SUBJECT: MAPLHGR AND HAFNIUM NEUTRON ABSORBER TECHNICAL SPECIFICATION
CHANGES (TAC 60174, 56512)

Re: Quad Cities Nuclear Power Station, Unit 1

Amendment No. 93
License No. DPR-29

SAFETY EVALUATION BY THE OFFICE OF NUCLEAR REACTOR REGULATION
SUPPORTING AMENDMENT NO. 93 TO FACILITY OPERATING LICENSE NO. DPR-29
COMMONWEALTH EDISON COMPANY
AND
IOWA-ILLINOIS GAS AND ELECTRIC COMPANY
QUAD CITIES NUCLEAR POWER STATION, UNIT 1
DOCKET NO. 50-254

MAPLHGR Vs. Average Planer Exposure
Fuel Type Bärrier LTA

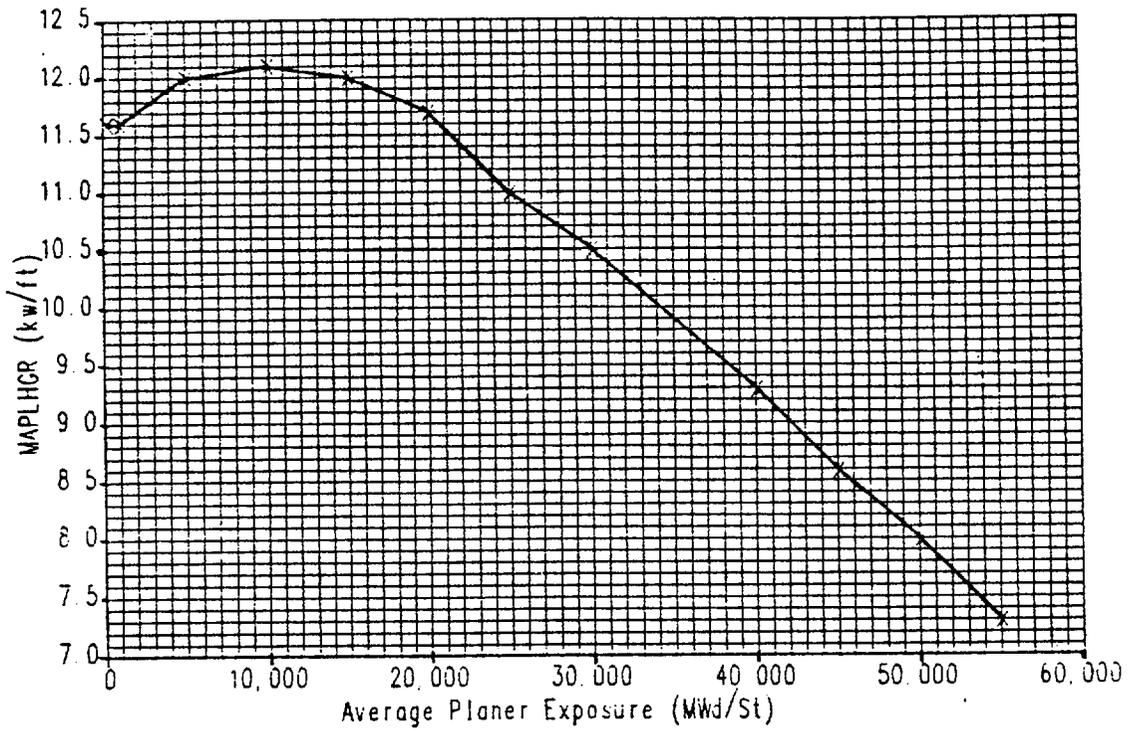
Reference 1 also contains a request to approve an extension of the MAPLHGR curve for fuel type "Barrier LTA" (BLTA) to 55,000 MWD/ST. The fuel assemblies for which the request is made are two assemblies of zirconium-lined fuel rods introduced into the core for reload for Operating Cycle 5, so the upcoming Operating Cycle 9 will be the fifth (and last) cycle of exposure for these test assemblies. The assemblies are designed to demonstrate improved fuel integrity under more-than-normal stress, including higher-than-normal burnup conditions. By letter dated August 13, 1985 (Reference 5), the NRC staff issued approval of the GE Topical Report NEDE-22148 (Reference 6) on extended burnup of GESTAR - referenced fuels (Reference 7). Reference 5 approves peak pellet exposure of BLTA to 60,000 MWD/MT. This approved exposure is greater than the 55,000 MWD/ST requested by the licensee, so the requested extended MAPLHGR value is within that reviewed and approved by NRC staff, so the requested change is acceptable.

MAPLHGR Vs. Average Planer Exposure
Fuel Type BP8DRB299

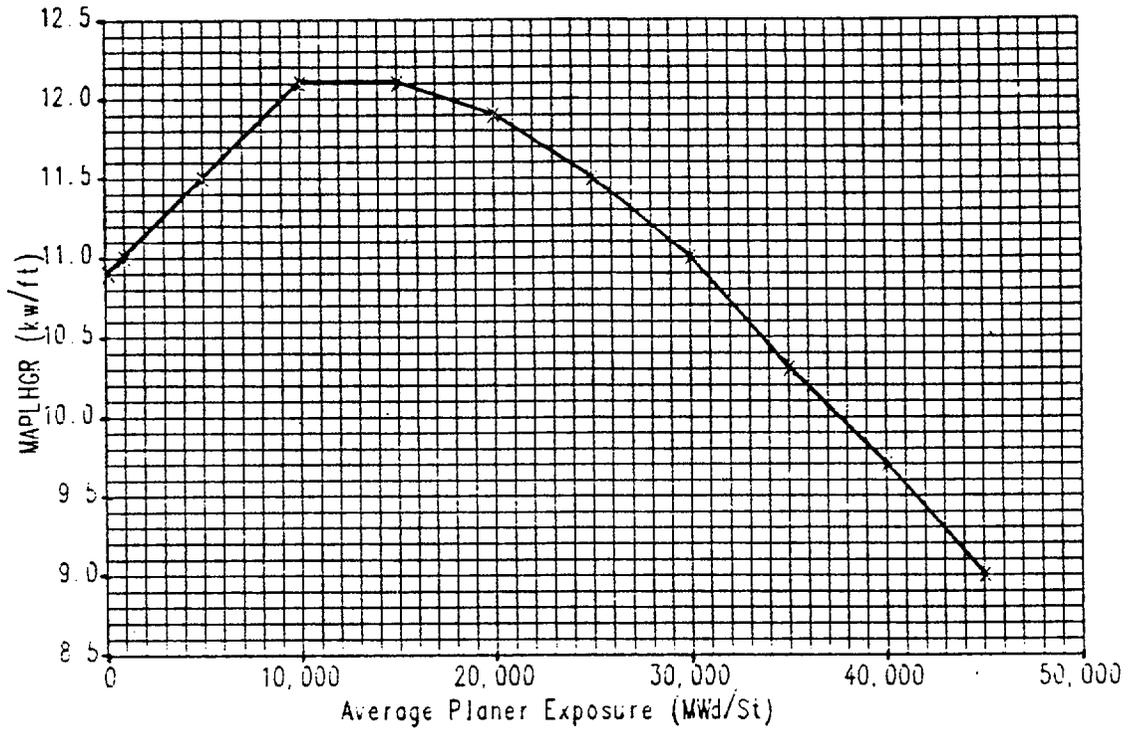
By letter dated October 29, 1985, Commonwealth Edison Company (CECo, the licensee) proposed changes to the Technical Specifications (TS) for Quad Cities Unit 1 (Reference 1). These changes would delete MAPLHGR curves for GE fuel type no longer used in the core, add MAPLHGR curves for GE fuel type BP8DRB282 and BP8DRB299 to be used in upcoming Operating Cycle 9, and extend the MAPLHGR curves for "Barrier LTA" fuel to planar average burnup of 55,000 MWD/ST. All MAPLHGR curves in the TS would be replotted for clarity, with page and sheet numbers adjusted as required to reflect the above additions and deletions.

No. 14 to Reference 4 are based on previously approved ECCS analyses contained in Reference 4, and so satisfy the requirements of the 10 CFR 50.46 acceptance criteria, they are appropriate for incorporation into the TS for Quad Cities Unit 1; therefore, the licensee's proposal to incorporate the MAPLHGR curves for fuel types BP8DRB282 and BP8DRB299 into the TS is acceptable.
